# HISTORIC PRESERVATION REVIEW BOARD STAFF REPORT AND RECOMMENDATION

Landmark/District: Address:	Capitol Hill Historic District 5 Walter Houp Court, N.E.	(x) Agenda ( ) Consent
Audress. ANC:	6A	(x) Concept
		(x) Alteration
Meeting Date:	November 2, 2023	( ) New Construction
Case Number:	23-507	( ) Demolition
		( ) Subdivision

Applicant Leslie Swift seeks concept review for a roof deck, rooftop additions, and covered pergola at a property located in the Capitol Hill Historic District.

Google aerial view of roof of 5 Walter Houp Court NE

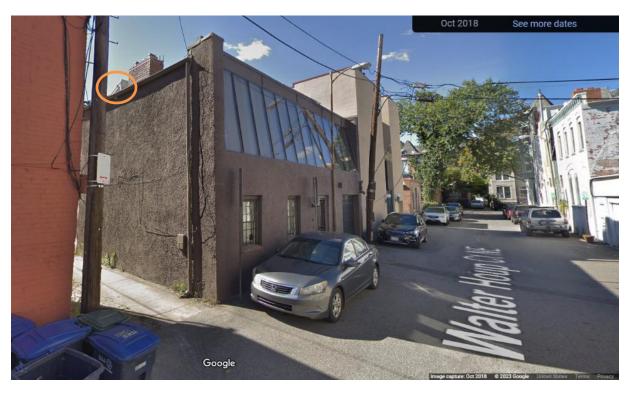
The Board has consistently found roof decks on two-story alley buildings to be incompatible with the Capitol Hill Historic District. The unpermitted alterations are highly visible from along the alley and Constitution Avenue and would not be approved as compatible if submitted for retroactive permit review.

The proposed alterations and additions to the existing illegal installations would be highly visible and disruptive of the roofline and massing of the building.

The HPO recommends the Board find the proposed alterations incompatible with the Capitol Hill historic district and deny the application.

View of 5 Walter Houp Court from alley, shed structure visible and circled

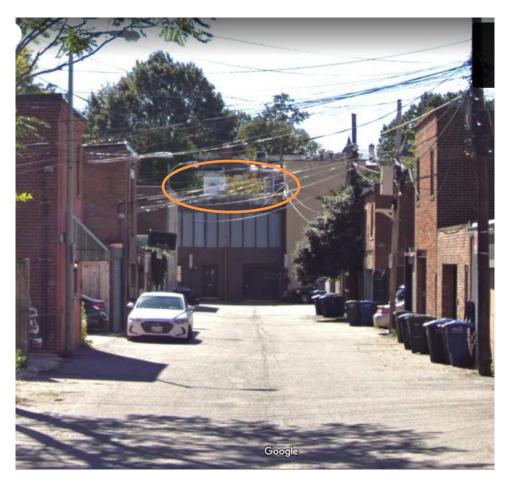
View from Constitution Avenue NE, solar panels and shed are highly visible
